## 2.4 Core Cooling Systems

The information in this section of the reference ABWR DCD, including all subsections, tables, and figures, is incorporated by reference with the following departures.

Figure 2.4.1a Residual Heat Removal System (RHR-A)

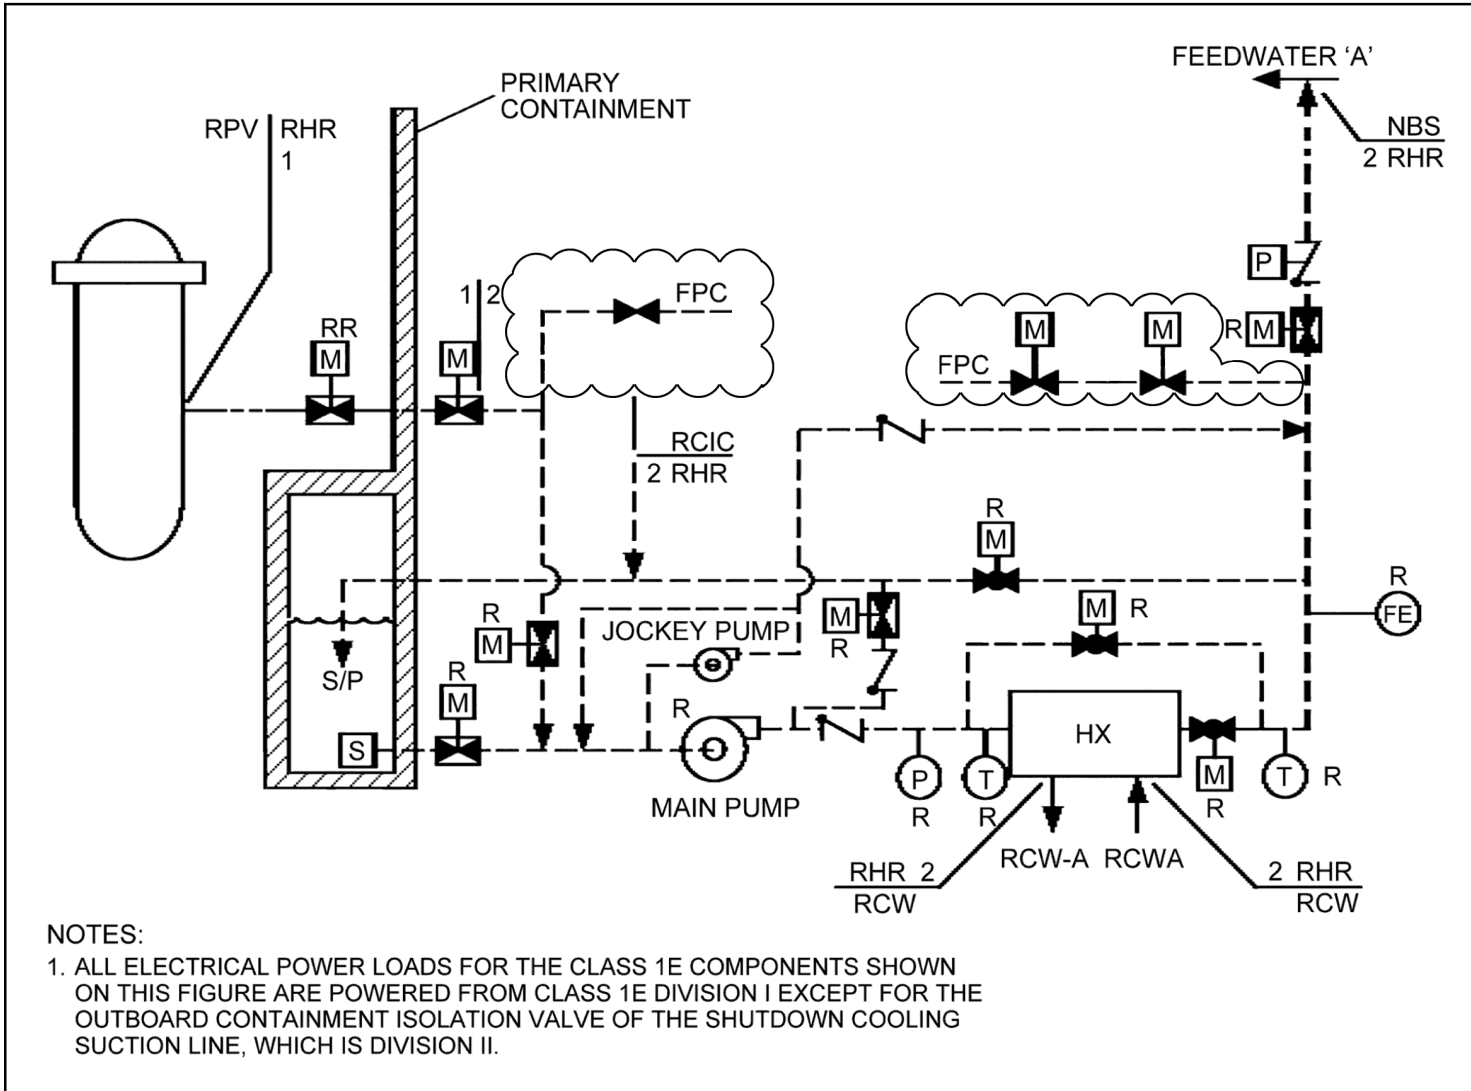
STD DEP T1 2.4-1 (Figure 2.4.1a, Table 2.4.1)

*The piping and components outside the shutdown cooling suction line containment isolation valves and outside the suppression pool containment isolation valves, and upstream of the suction side of the pump with all its branches have a design pressure of 2.82 MPaG for intersystem LOCA (ISLOCA) conditions. Refer to Figures 2.4.1a, 2.4.1b, and 2.4.1c. ~~For RHR A, the upgraded branch lines from the main pump suction include the path to and including the suppression pool suction valve, the path to the shutdown cooling outboard containment isolation valve, and the path to the jockey pump's discharge check valve including the jockey pump's bypass return line. For RHR B and C, the upgraded branch lines include all the paths listed for RHR A plus the path to (and including the valve) the Fuel Pool Cooling System that branches off~~*

~~the shutdown cooling suction line, titled "From FPC."~~ For RHR A and B, the upgraded branch lines from the main pump suction include the path to and including the suppression pool suction valve, the path to the shutdown cooling outboard containment isolation valve, the path to the jockey pump's discharge valve including the jockey pump's bypass line and the path to the (and including the valve) the Fuel Pool Cooling System that branches off the shutdown cooling suction, titled, "From FPC." For RHR-C, the upgraded branch lines include all the paths listed for RHR-A and B plus the pipeline and valves that are part of the AC independent water addition mode that extends from the noncode boundary indicated by "NNS" to the "external connection" outside the "reactor building" and to the Fire Protection System interface indicated by "FP."

**Figure 2.4.1b Residual Heat Removal System (RHR-B)**

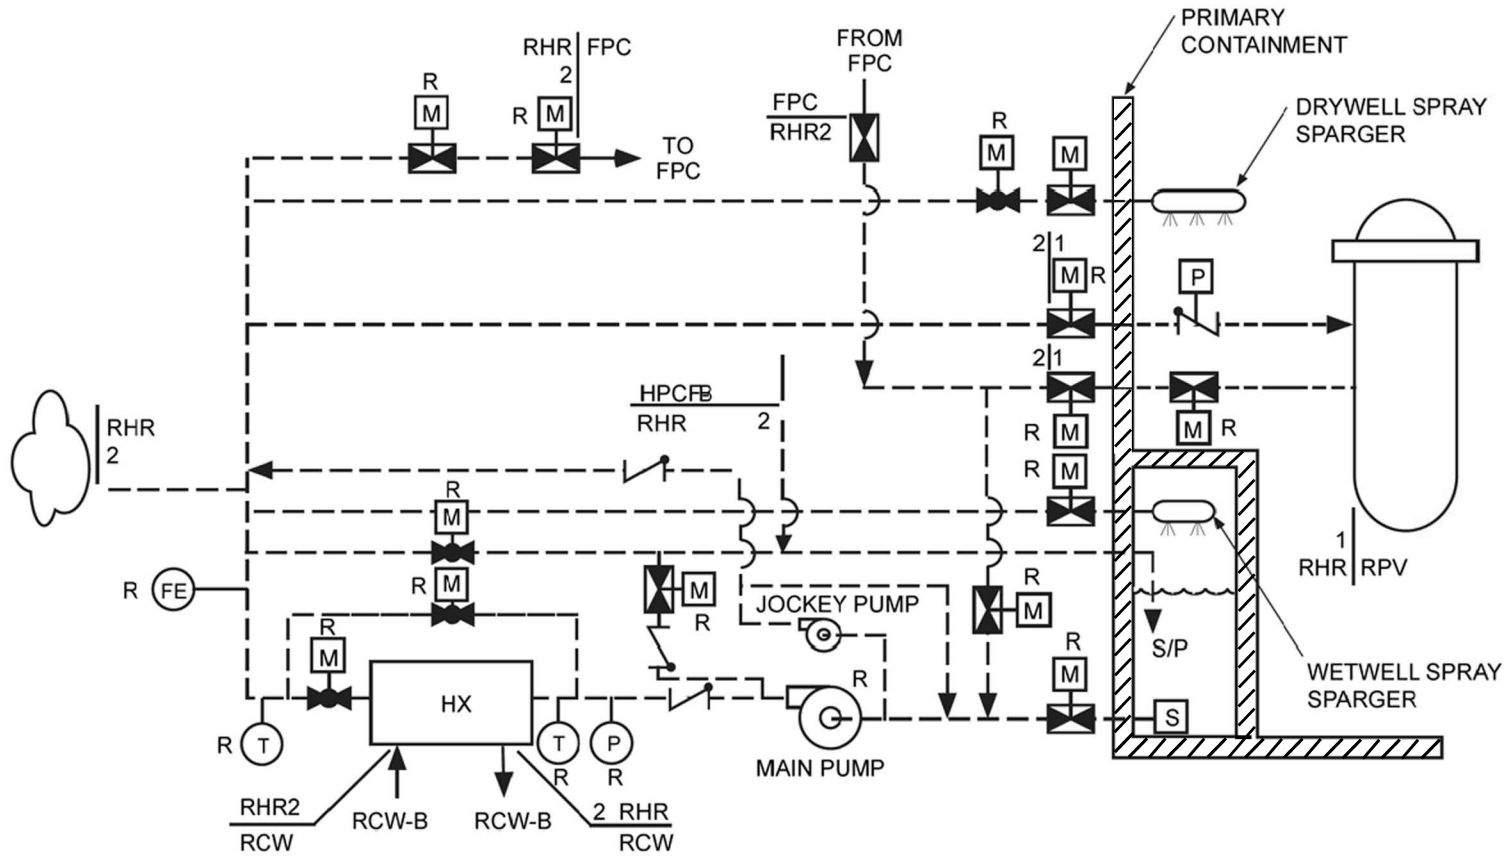
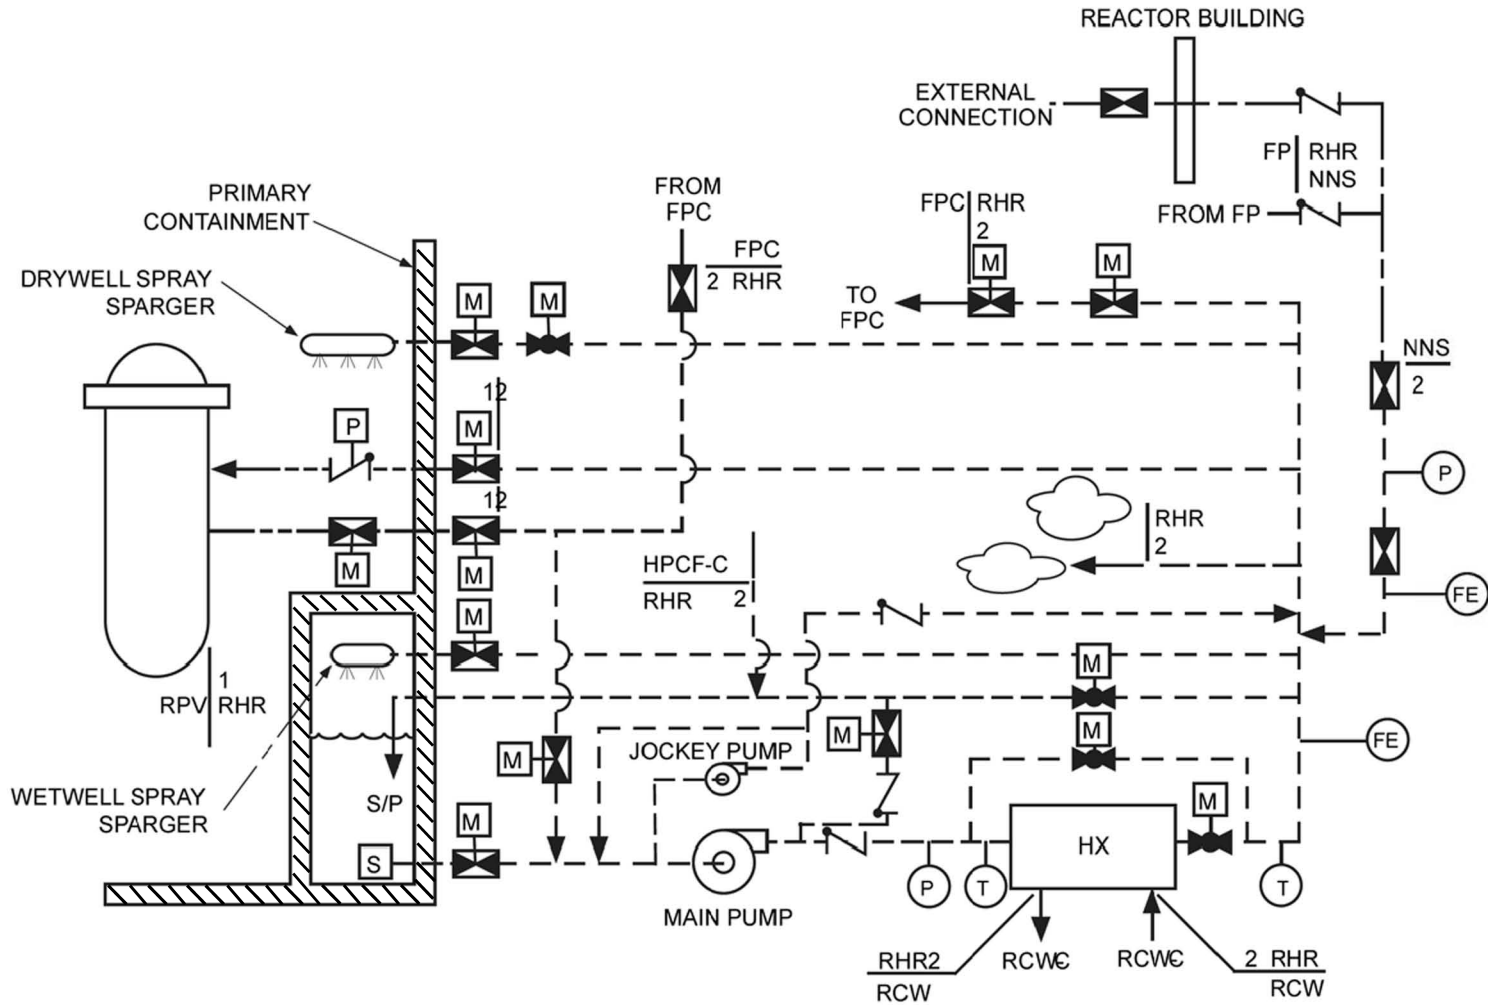
STD DEP T1 2.14-1 (Figure 2.4.1b, Figure 2.4.1c, Figure 2.4.3)

Figure 2.4.2 Leak Detection and Isolation System Interface Diagram

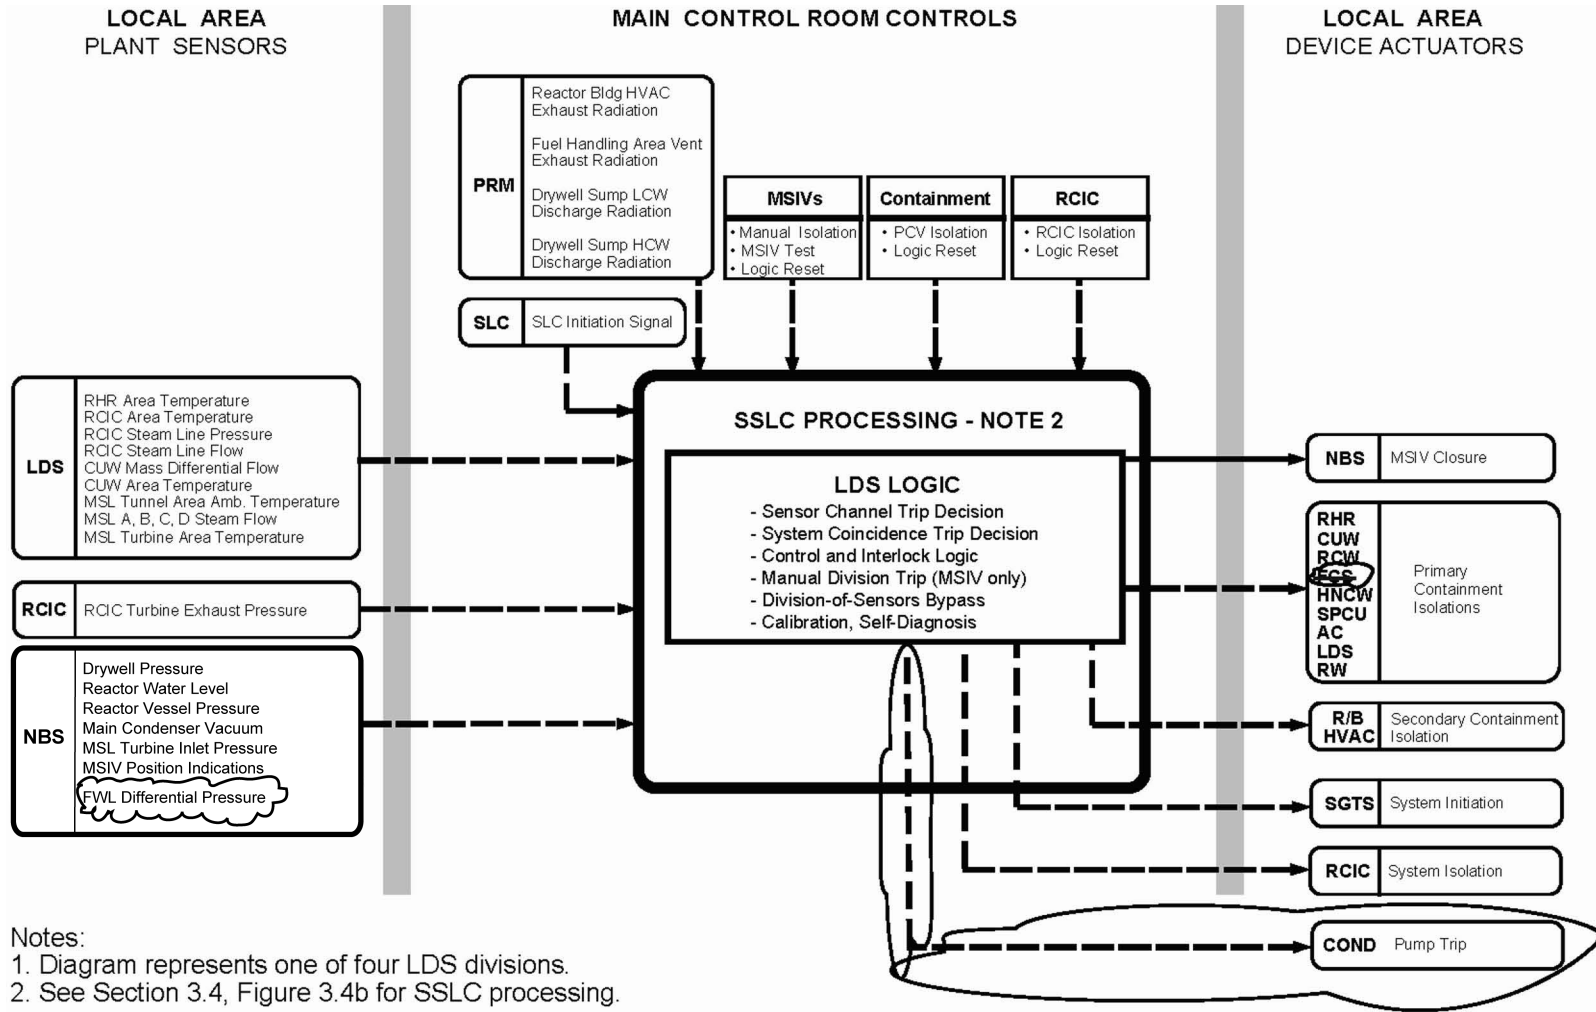
STD DEP T1 2.4-2 (Leak Detection System) Figure 2.4.3

STD DEP T1 2.14-1 (FCS, Figure 2.4.3)

- (9) *Isolation of the Suppression Pool Cleanup (SPCU) System on a signal indicating high drywell pressure or low reactor water level.*
- ~~(10) *Isolation of the Flammability Control System (FCS) on a signal indicating high drywell pressure or low reactor water level.*~~

- (10) ~~(11)~~ *Isolation of the drywell sump low conductivity waste (LCW) and high conductivity waste (HCW) discharge lines on a signal indicating high drywell pressure or low reactor water level. Also, each discharge line is individually isolated on a signal indicating high radioactivity in the discharged liquid waste; only one channel is used for this function.*

- (11) ~~(12)~~ *Isolation of the LDS fission products monitor drywell sample and return lines on a signal indicating high drywell pressure or low reactor water level.*

- (12) ~~(13)~~ *The LDS provides to the neutron monitoring system a signal indicating a high drywell pressure or low reactor water level.*
- (13) *The LDS provides a trip of the condensate pumps on signals that indicate high drywell pressure and high differential pressure between the feedwater lines.*

Figure 2.4.4a Reactor Core Isolation Cooling System

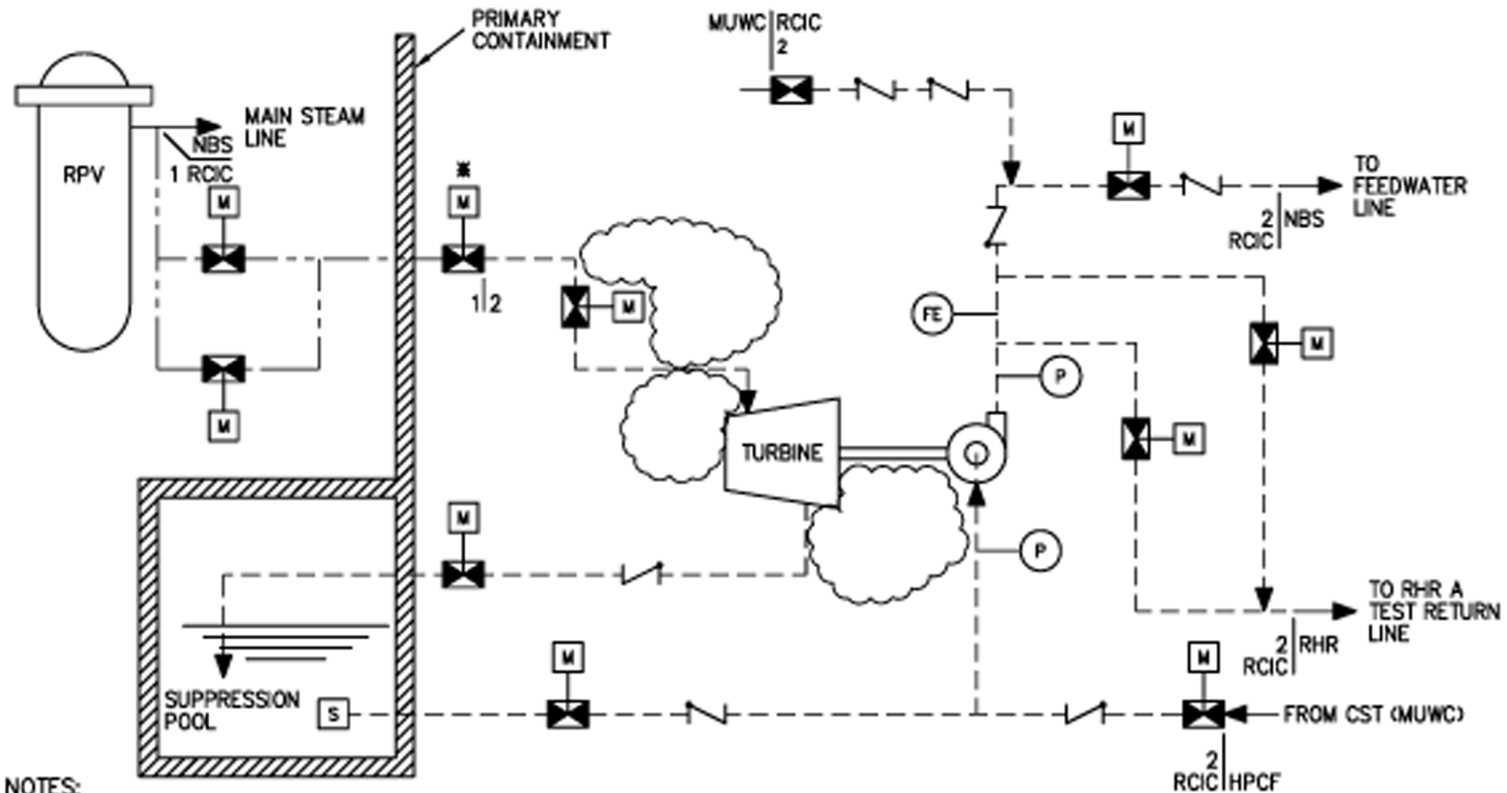
STD DEP T1 2.4-3 (Figure 2.4.4a, Table 2.4.4.)

- (1) Piping and component from the pump suction MOV's up to the pump inlet,*
- ~~(2) Barometric condenser and associated equipment.~~*
